Access Compliance Report Public Rights-of-Way (Curb Ramps)

Main Street: RANUNCULUS_ST		Cross Street: SKLAR_ST		Location:	SE
ADA ID: RPAT211029151722	Ramp Type: Type 4 - Parallel	Initial Pass/Fail: Fail	Overall Compliance: No	Severity Score:	16
Codes/Mitigation Info/Possible Solution			Field Measurements/Component Compliance

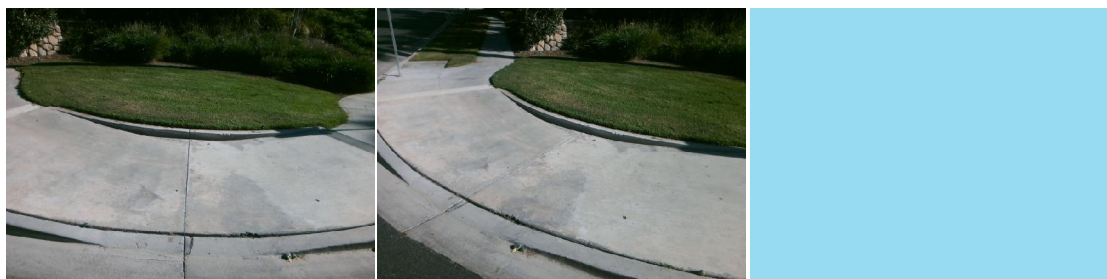
R204.3, R304.3.2, R304.5.3, STD 1115

Compliance	Description	Data	Compliance	Description	Data
N/A	Ramp Length LT (in)	92	N/A	Ramp Length RT (in)	100
Yes	Ramp Width LT (in)	90	Yes	Ramp Width RT (in)	89
No	Ramp Run Slope LT (%)	11.3	Yes	Ramp Run Slope RT (%)	2.5
No	Ramp Cross Slope LT (%)	2.7	No	Ramp Cross Slope RT (%)	2.7
N/A	Landing Present	N/A	N/A	DWS Provided	N/A
N/A	Landing Length (in)	N/A	N/A	DWS Contrast	N/A
N/A	Landing Width (in)	N/A	N/A	DWS Length (in)	N/A
N/A	Landing Run Slope (%)	N/A	N/A	DWS Full Width	N/A
N/A	Landing Cross Slope (%)	N/A		DWS Offset Type	N/A
N/A	Landing Movement Obstructed?	N/A	N/A	DWS Offset Left (in)	N/A
	Landing Movement Type	N/A	N/A	DWS Offset Right (in)	N/A
N/A	Landing Shared	N/A			
N/A	Clear Space	Yes			
N/A	Clear Space To Crosswalk (in)	N/A			
N/A	Marked Crosswalk 1	No	N/A	Marked Crosswalk 2	No
	Crossing 1 Direction	NE		Crossing 2 Direction	NW
	Marked Crosswalk 1 Width (in)	N/A		Marked Crosswalk 2 Width (in)	N/A

Remove & Replace Curb Ramp With Two New Directional Ramps or Equivalent.
